To: Members of Dublin City Council

Date: January 23, 2014

Re: Ord. 70-13 - Rezoning Approximately 10.5 acres, Located on the West Side of Paul Blazer Parkway, between the Intersections of Rings Road and Parkcenter Circle from PCD, Planned Commerce District (Tuttle Crossing/I-270, Subarea 5A) to PUD, Planned Unit Development District (Tuttle Crossing/I-270, Subarea 5A) to Modify the Development Text and Preliminary Development Plan regarding Sign and Parking Requirements. (Case 13-056Z/PDP)

CITY OF DUBLIN, FRANKLIN COUNTY, OHIO
PRELIMINARY DEVELOPMENT PLAN
 FOR
5515 PARKCENTER CIRCLE
SITE IMPROVEMENTS
 2014

CITY OF DUBLIN, FRANKLIN COUNTY, OHIO
PRELIMINARY DEVELOPMENT PLAN
FOR
5515 PARKCENTER CIRCLE
SITE IMPROVEMENTS
SIGN DETAILS

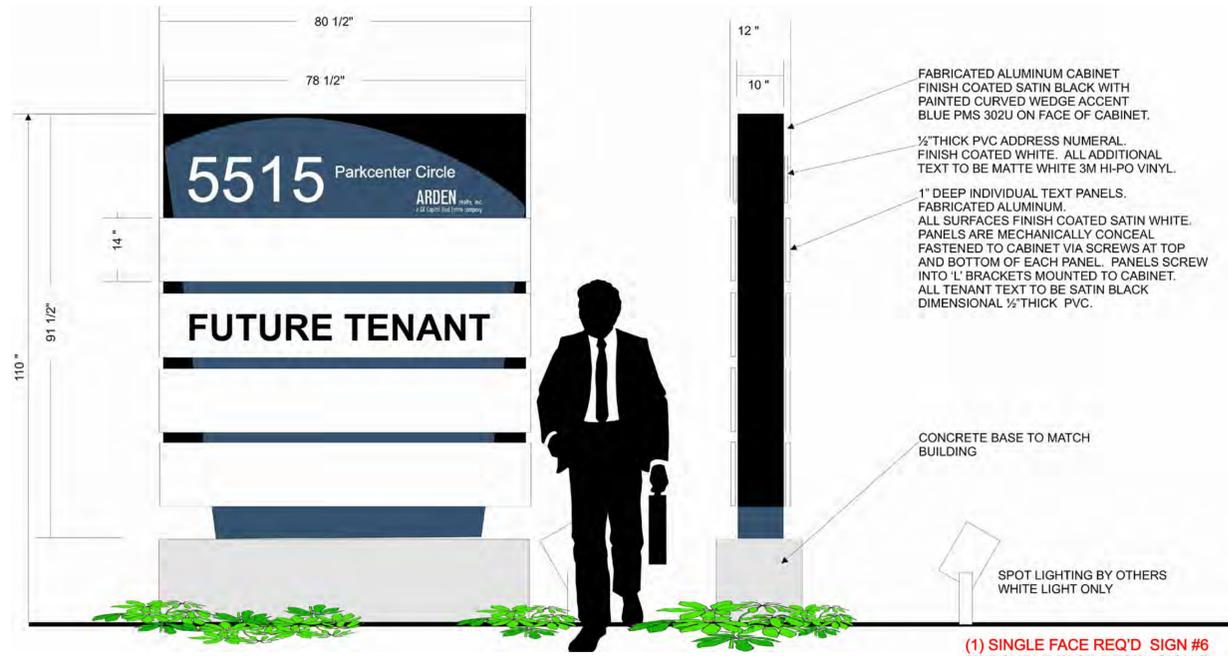
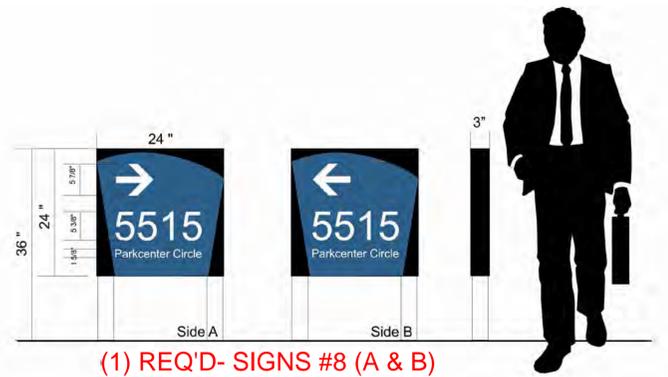
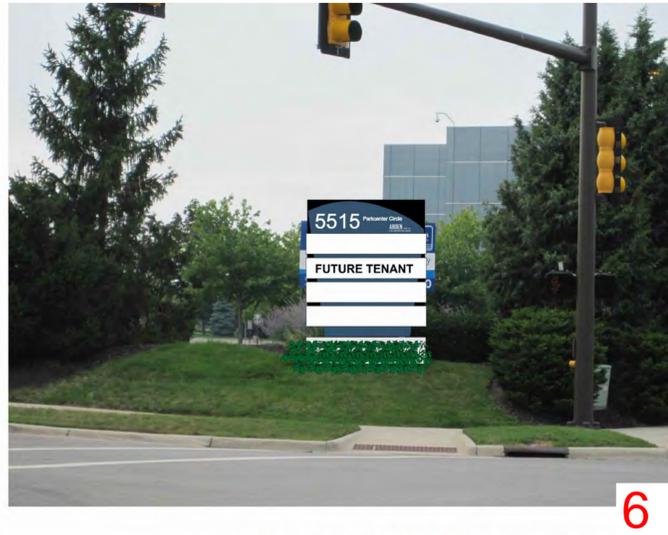
Council expressed concerns about the proposed sign package outlined in the development text. The applicant has provided preliminary sign details for Council's reference. Final details will be approved as part of the final development plan review by the Planning and Zoning Commission.

3. The trees planted on site be staggered along the perimeter of the parking areas, to the extent possible to fill in the sparse areas.
4. One of the two proposed signs located along the Parkcenter Circle frontage be eliminated.

5. The overall height of the canopy sign be limited to 15 feet.
6. A final sign plan be presented as part of the final development plan.
7. The applicant eliminate the provisions for a tenant sign on the building elevation.
